STAFF RECOMMENDATION

1715 Sweetbriar Avenue

January 17, 2018

Application: Demolition; New construction-infill

Figure 1. 1715 Sweetbriar Avenue

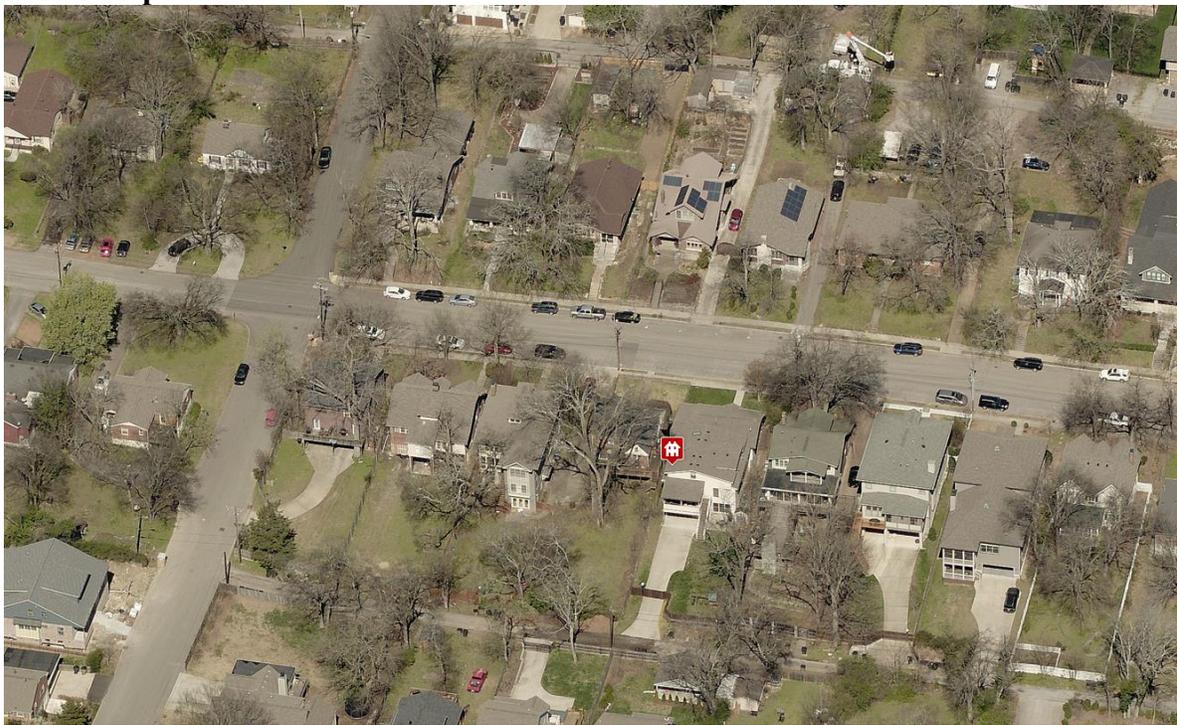
Demolition: 1715 Sweetbriar Avenue was constructed c. 1950, later than the historic houses in the immediate vicinity. This block of Sweetbriar Avenue largely developed from 1900 to 1930 (see context photos). This house is the only house on this block that was built from the 1940s through the 1950s. As such, it is an anomaly for this part of Sweetbriar. In addition, the house's materials, form, and architectural details do not meet the historic context. Staff finds that 1715 Sweetbriar Avenue does not contribute to the historic character of the Belmont-Hillsboro Neighborhood Conservation Zoning Overlay. Staff therefore finds that its demolition meets Section V.2. of the design guidelines and does not meet Section V.1.

FRONT ELEVATION

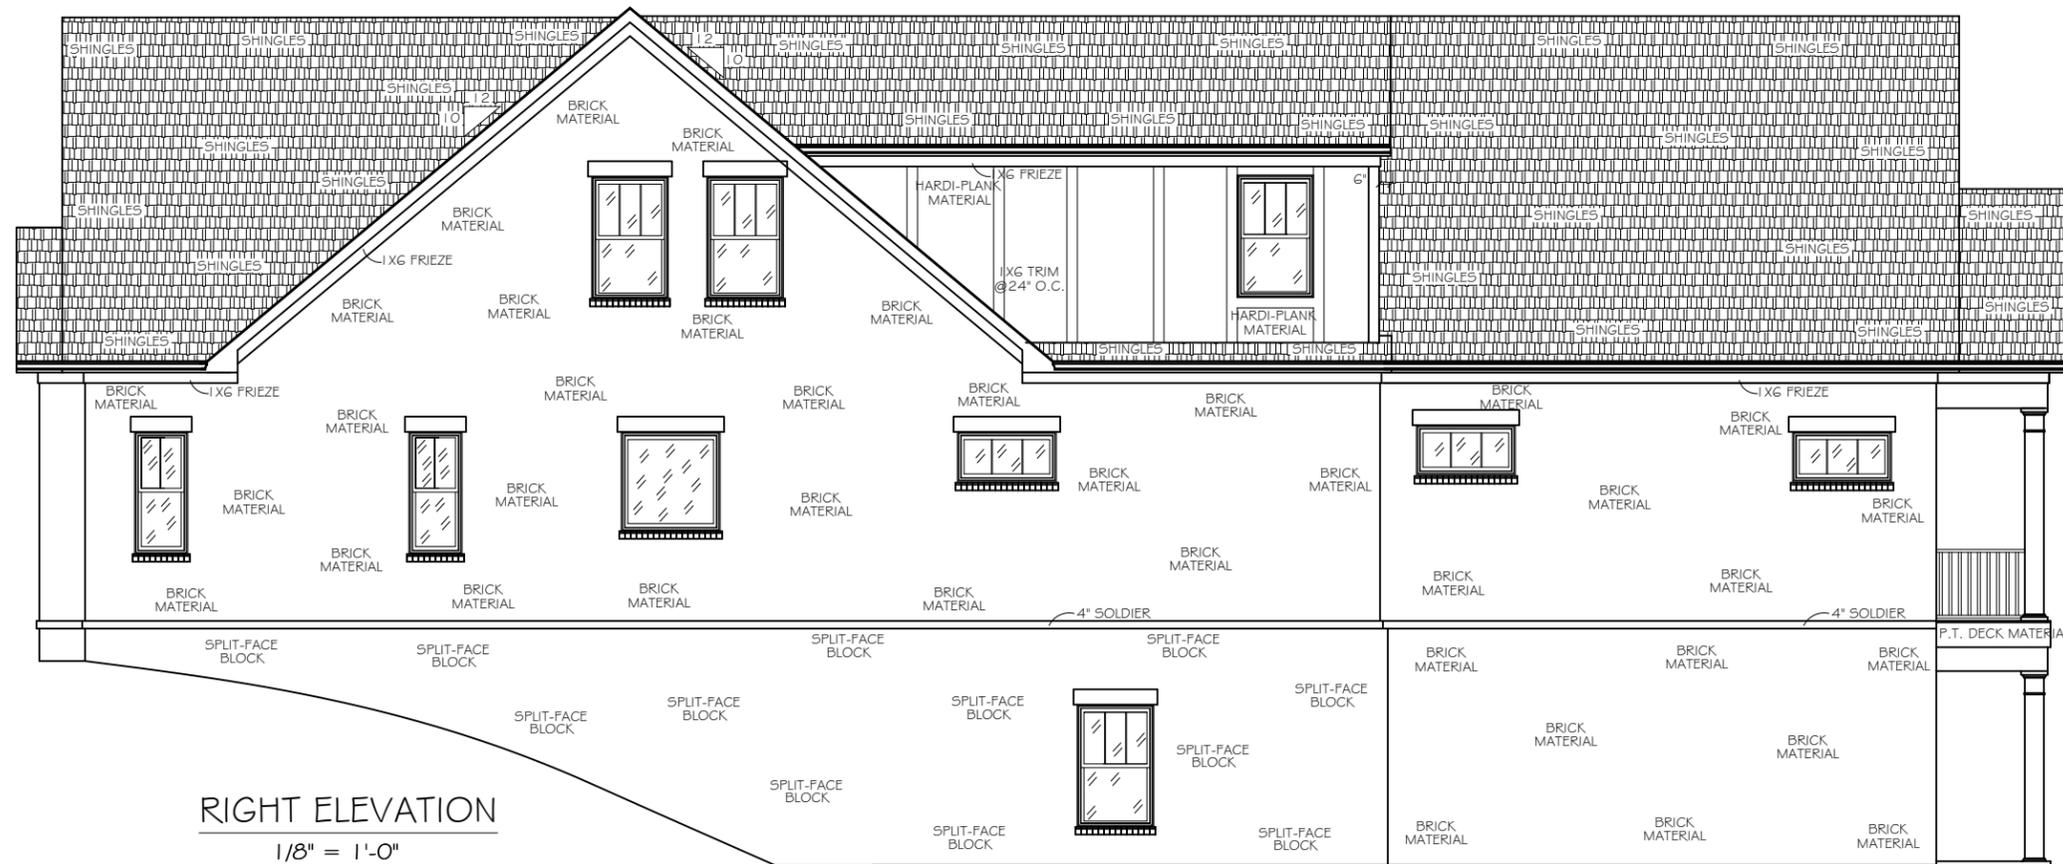
Roof form: The primary roof form is a cross gable. The front-facing gable has a slope of 14/12, while the side gable has a slope of 10/12. The front façade has a shed dormer with a slope of 4/12. The dormer is set back two feet (2') from the wall below. The side elevations also contain shed dormers which are set back two feet (2') from the wall below. Staff finds that the proposed roof forms meet section II.B.1.e. of the design guidelines.

Orientation: The house is oriented to face Sweetbriar Avenue, which is appropriate. The front entry is behind a covered stoop that is six feet, eight inches (6'8") deep. Staff recommends the installation of a front walkway leading from the sidewalk to the front stoop. Vehicular access will be via the rear alley, which is appropriate. Staff finds that the infill's orientation meets Section II.B.1.f. of the design guidelines.

LEFT ELEVATION
1/8" = 1'-0"

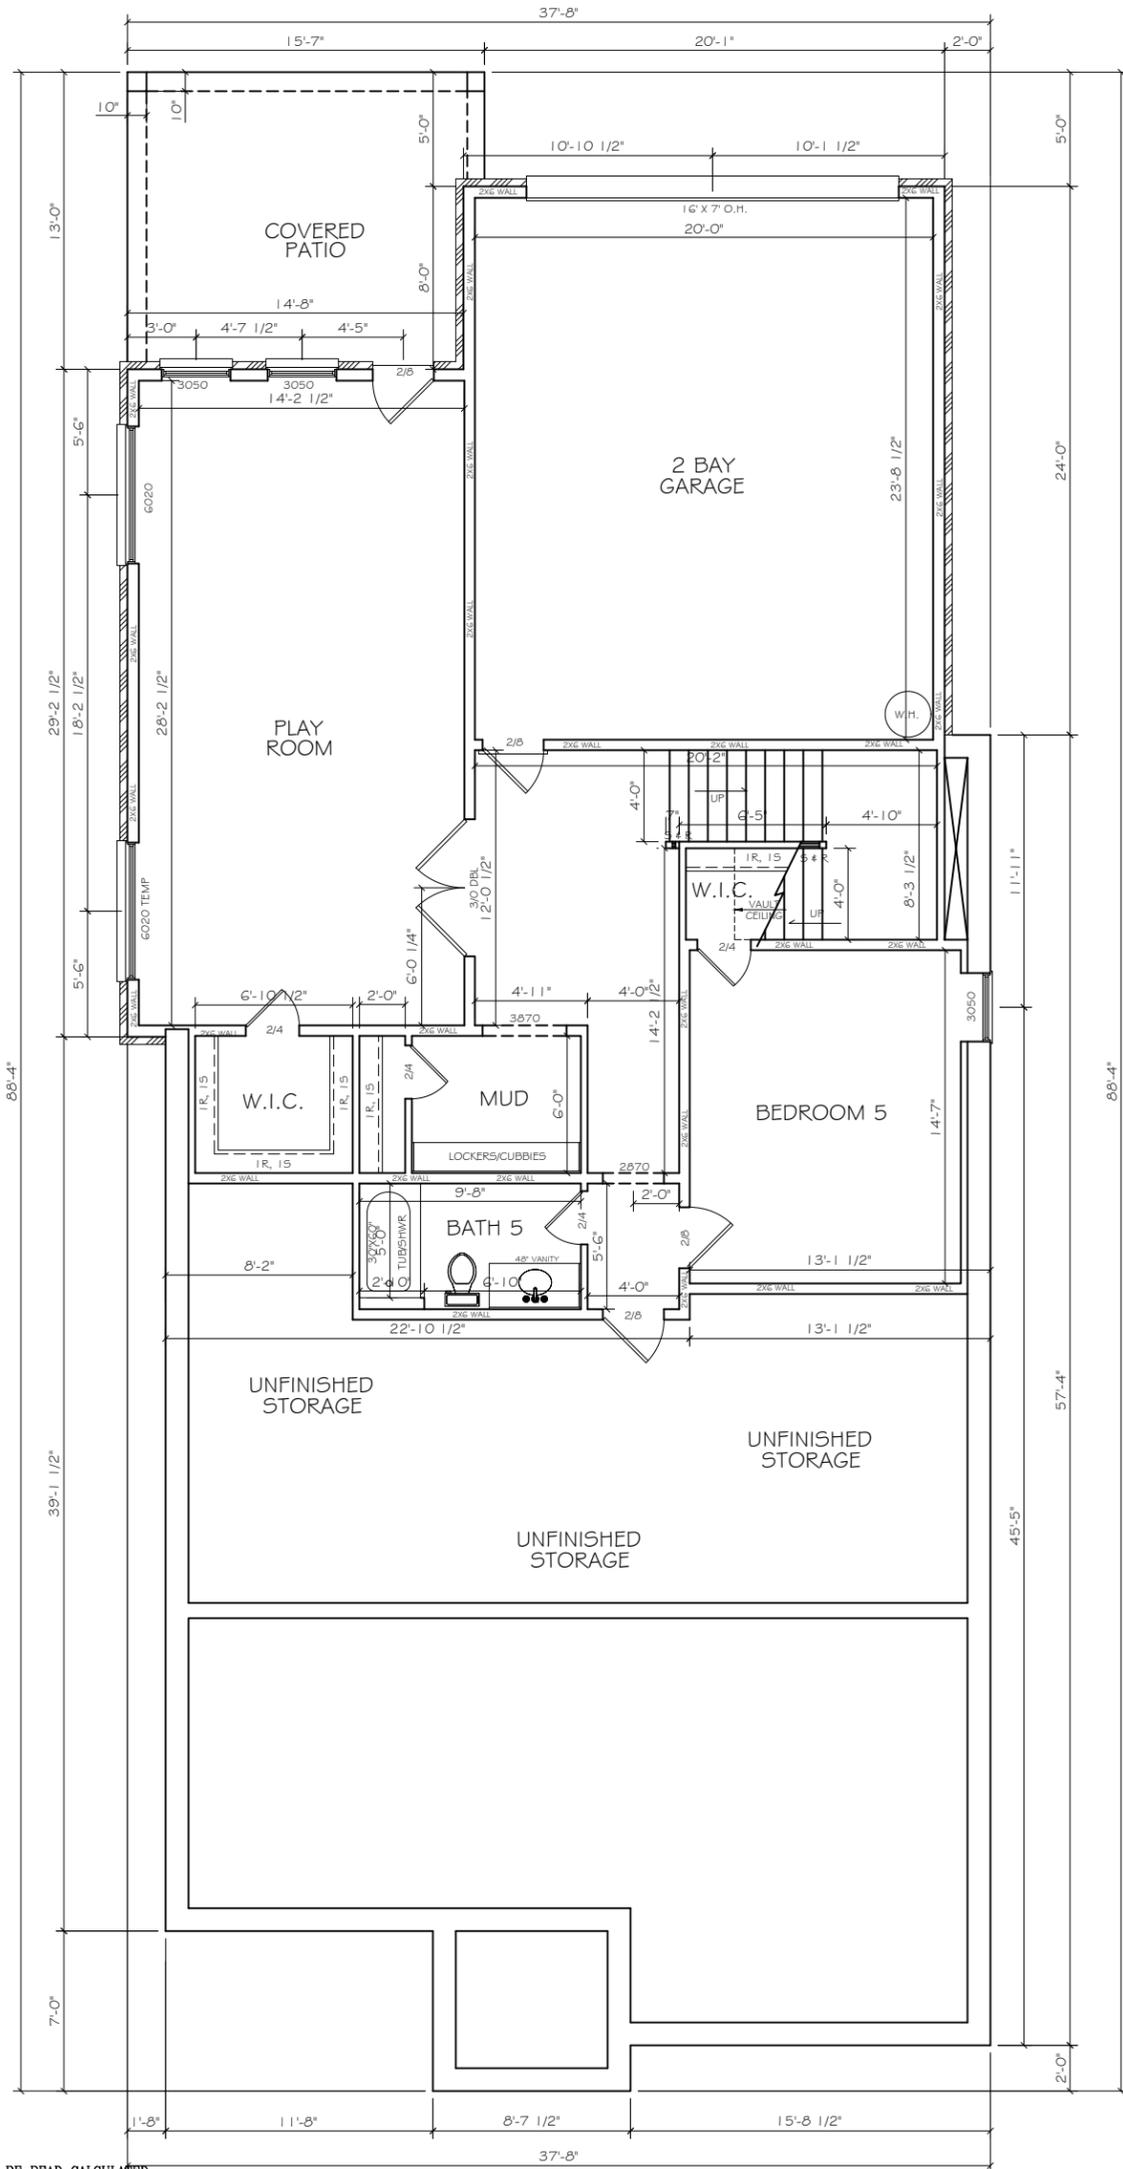
Proportion and Rhythm of Openings: The windows on the infill addition are mostly twice as tall as they are wide, thereby meeting the historic proportions of openings. On the right façade, there is one square picture window opening and three horizontal window openings. While unusual, staff finds them to be appropriate because of their location. The picture window opening is over twenty-five feet (25') from the front façade, and the horizontal window openings are over forty feet (40') from the front. There are no large expanses of wall space without a window or door opening. Staff finds the project's proportion and rhythm of openings to meet Section II.B.1.g. of the design guidelines.
